CORAL-2 Questions & Answers

January 15, 2018

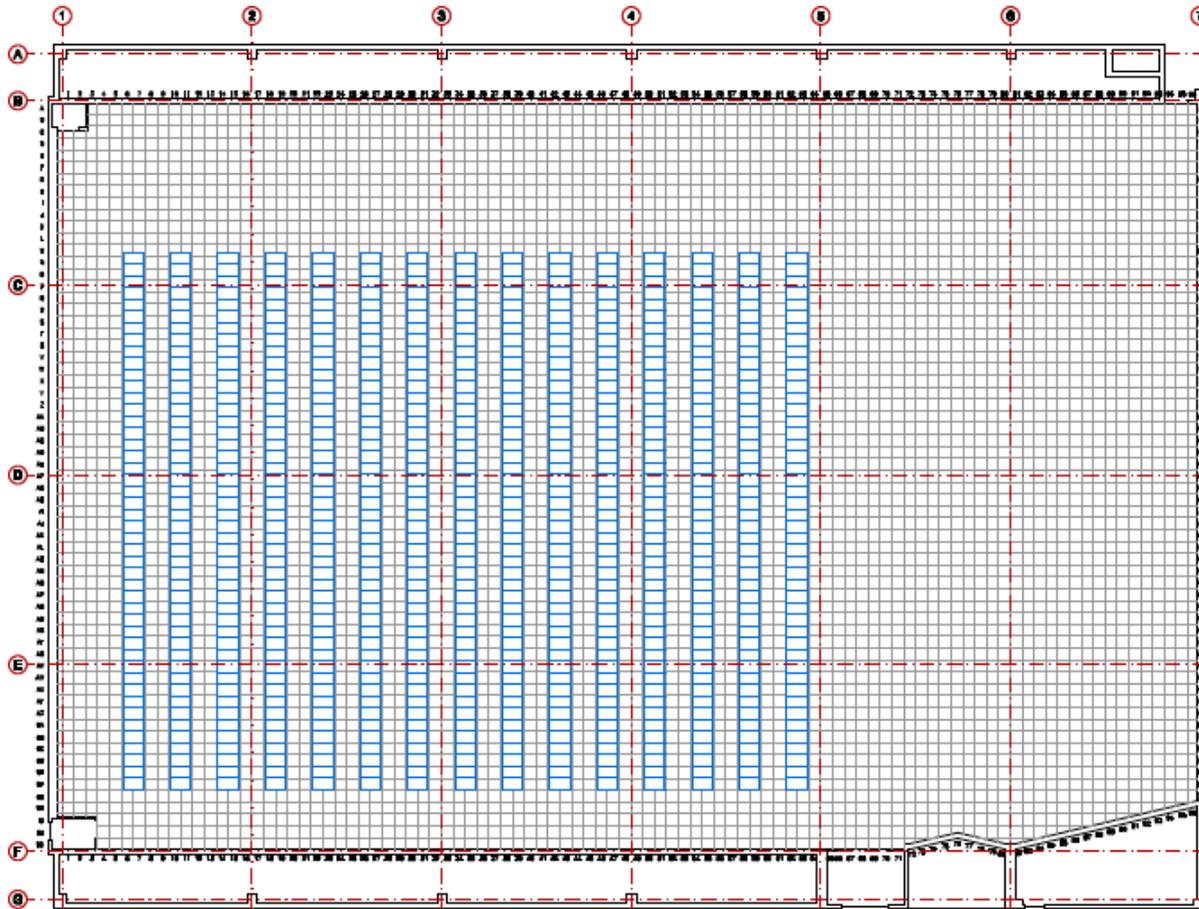
11. Section 12 CORAL Facilities Requirements: What is the minimum acceptable service aisle width between adjacent rows of Offeror provided equipment in the CORAL-2 system?

[ORNL] There is no explicit service aisle width minimum between adjacent rows of Offeror-provided equipment. Offeror should stipulate the minimum service aisle requirement for each distinct system type, cabinet, or similar, as part of a description of their potential system layout. For example, compute cabinets, storage cabinets, network cabinets, and CDU may all have different dimensions and service/accessibility requirements.

ORNL maintains a 40" service minimum in front of all switchboards, electrical panels, PDUs, and air-conditioning units. Offeror should consider the impact of these 40" minimum clearance requirements. Freight aisles have a preferred width of 72".

The raised floor grid uses 24"x24" tiles. Minimizing overlap of equipment and tiles will enhance serviceability beneath the floor.

[LLNL] The minimum service aisle width between adjacent rows of Offeror-provided equipment is 4'. This width may need to be increased to adequately install all power and cooling solutions; however, the raised floor grid uses 24"x24" tiles so minimizing overlap of equipment and tiles will enhance serviceability beneath the floor.

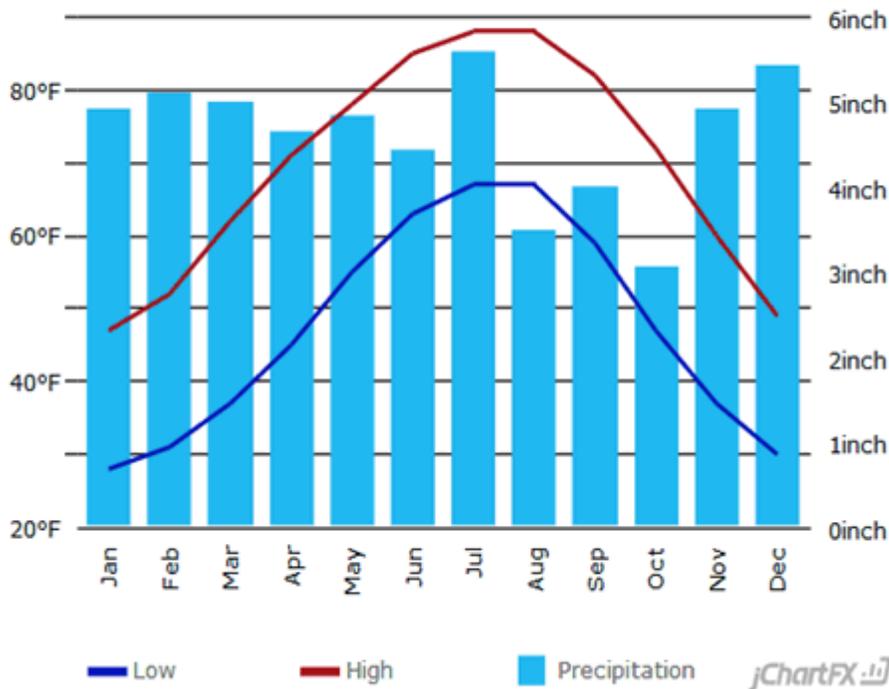
3. If LLNL will not provide a facility CDU, what is the primary water temperature that is provided?

4. In either case, how will the water temperature vary throughout the year?

60F to 85F

Across that range above. Colder in the winter and warmer in the summer.
